RISO, INC. **TECHNICAL INFORMATION BULLETIN**

Subject: NEW THERMAL HEAD CHART — Bulletin No.: 90

A new Thermal Head Chart has been released for machines operating under low temperature conditions. Applies to System Main ROM versions S11/Ver.1.31 and above, S11G/Ver.5.14 and above, S22G/Ver.1.13 and above.

Change of DIP SW Setting on Image Processing PCB

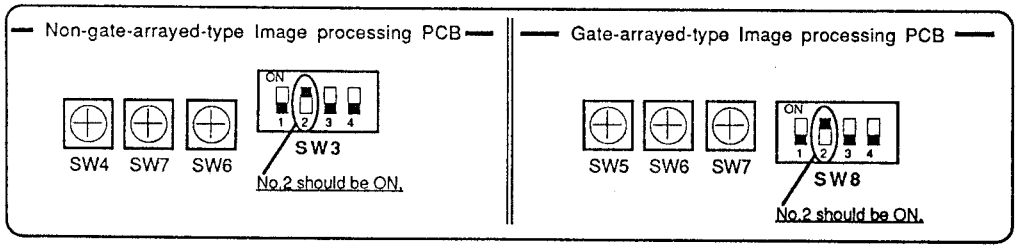
* "SW3" & "SW4" in the column of "Switch setting" of the above thermal power setting chart correspond to "SW5" & "SW8" of the Non-gate-arrayed-type Image processing PCB.

Voltage VTPH(V)	Resistance value R (Ω)	Switch setting SW3/SW4
18.0	1520-1542	C / B
	1543-1574	D / D
	1575-1601	E / E
18.0	1602-1623	C / C
	1624-1656	D / D
	1657-1686	E / E
18.5	1687-1703	9 / 9
	1704-1737	A / A
	1738-1775	B / B
18.5	1776-1789	9 / 9
	1790-1823	A / B
	1824-1858	B / C
	1859-1870	C / D
19.0	1871-1874	6 / 6
	1875-1911	7 / 8
	1912-1947	8 / 9
	1948-1969	9 / A
19.0	1970-2002	7 / 8
	2003-2038	8 / 9
	2039-2074	9 / B
19.0	2075-2093	7 / 9
	2094-2129	8 / A
	2130-2166	9 / B
	2167-2184	A / D
19.0	2185-2220	8 / B
	2221-2257	9 / C
	2258-2300	A / D
